Appendix M

Comments on the Draft EIS

APPENDIX M – PUBLIC COMMENT LETTERS

This appendix of the Desert Harvest Solar Project Final EIS and Proposed CDCA Plan Amendment includes the full text of comments received on the Draft EIS. Each comment letter is bracketed with an alphanumeric code to delineate discrete comments or concepts. Each bracketed comment has received an individual response in this Final EIS. Appendix N provides responses to all comments.

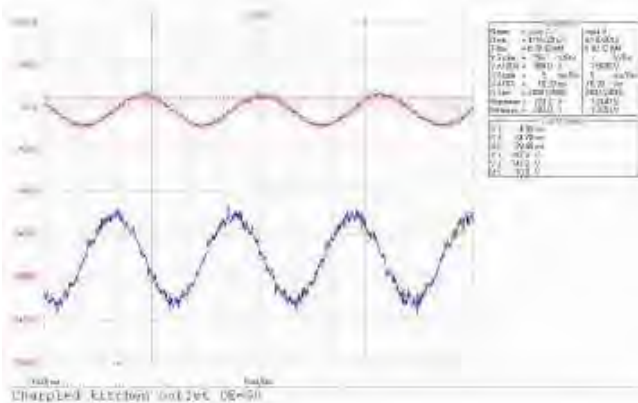
Dr. Milham traveled to the Charpiet farm in April 2012, to obtain "dirty electricity" readings from our home, office, and outdoors for baseline information. He will be back to perform some more readings once the Desert Sunlight project goes on line.

The readings inside our home were good - inside the safe level for such things. The readings in our office were a bit high, but that was

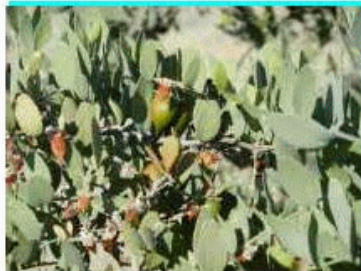
Today, we cannot even count the number of times dust engulfed our community from the construction of Desert Sunlight. Except after a rare rain event, there is constantly dust in the air. First Solar uses palliatives and water to suppress the dust, and in fairness do they best that they can, but it is inadequate.

One reason dust is significantly impacting air quality and human health is that they cleared approximately 1,000 acres of land on their southeast that has sat denuded for nearly a year, and several hundred acres for storage in the north. Dust picks up from those areas first and gains momentum engulfing the valley. Desert Harvest, as part of mitigation for dust control, ***MUST construct the project in 100 acre chunks, and not clear the entire area at once.***
